**TOWN OF STRATFORD
BID #2016-004**

**ADDENDUM #1
Issued 2/16/16**

REHAB OF CANAAN RD & LIGHT ST BRIDGES

REHABILITATION OF CANAAN ROAD AND LIGHT STREET BRIDGES
STRATFORD, CONNECTICUT
February 15, 2016

BRUCES BROOK — STRATFORD CONN. —
CONCRETE BRIDGE AT CANAAN ROAD —
Scale 1/2" = 1 foot unless otherwise noted April 1940

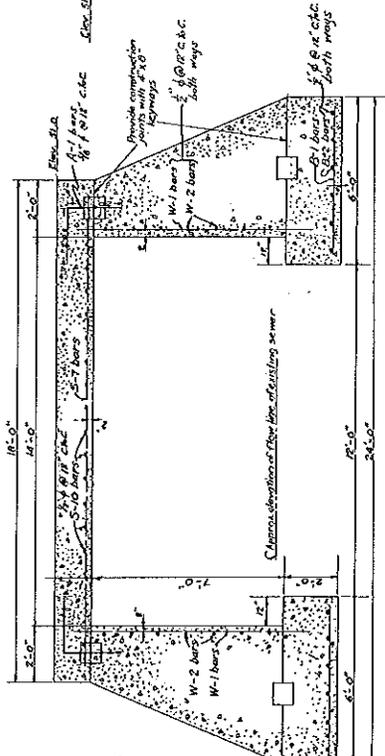
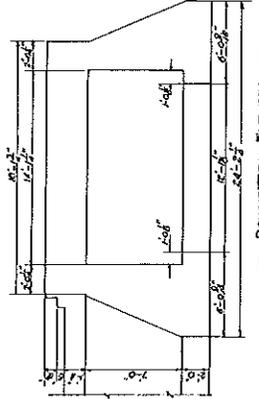
Are there details on how the existing bridge decks are connected to the existing abutments?

See attached plans for existing construction details.
